## WESTSIDE SUBWAY EXTENSION PROJECT

# Addendum to the Hydrology and Water Quality Technical Report

August 2011

Figure 4-5. FEMA Floodplains in the Vicinity of the Build Alternative

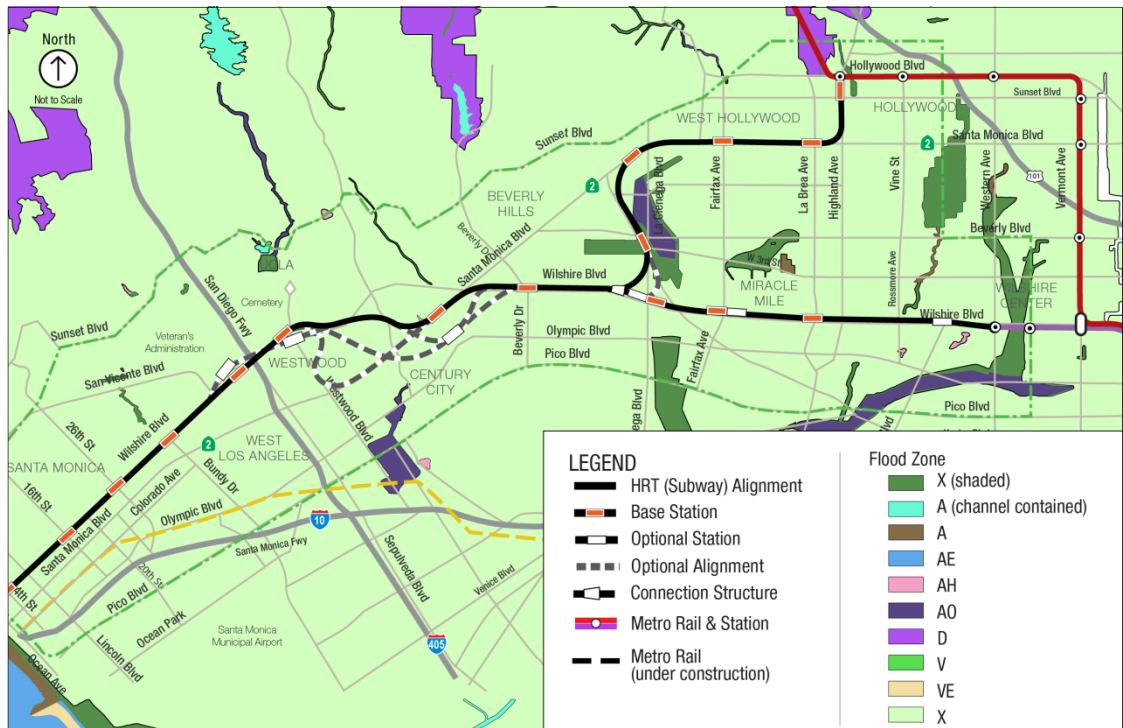
*Change* The following is a modification of and replaces Section 4.5.1.

Areas along the alignment of the Build Alternatives contain 500-year and 100-year floodplain (FIRMs: 06037C1580F, 06037C1557F, 06037C1556F, 06037C1552F, 06037C1288F, 06037C1290F, 06037C1295F, 06037C1551F, 06037C1532F, 06037C1533F, 06037C1529F, 06037C1528F, 06037C1536F, 06037C1517F, 06037C1519F).

Most of the alignments of the Build Alternatives are within the FEMA-designated floodplains Zone X and Zone X (shaded). Zone X is defined as areas of minimal flood hazard, usually depicted on FEMA flood zone maps as above the 500-year flood level; Zone X (shaded) is defined as areas of moderate flood hazard, usually depicted in FEMA flood zone maps as above the 500 year flood level.

Areas of 100-year floodplain occur along North La Cienega Boulevard to the north and south of the intersection at Burton Way. The 100-year floodplain in this area is designated as AO, which means it is subject to a one percent annual chance of shallow flooding hazards in the form of sheet flow (average depths ranging from 1 to 3 feet). Another 100-year flood plain lies adjacent to Santa Monica Boulevard south of the intersection with Wilshire Boulevard. This area is designated as AH, which means it is subject to one percent annual chance of shallow ponding (average depths range from 1 to 3 feet). Figure 4-5 shows these floodplain areas along the Build Alternatives.
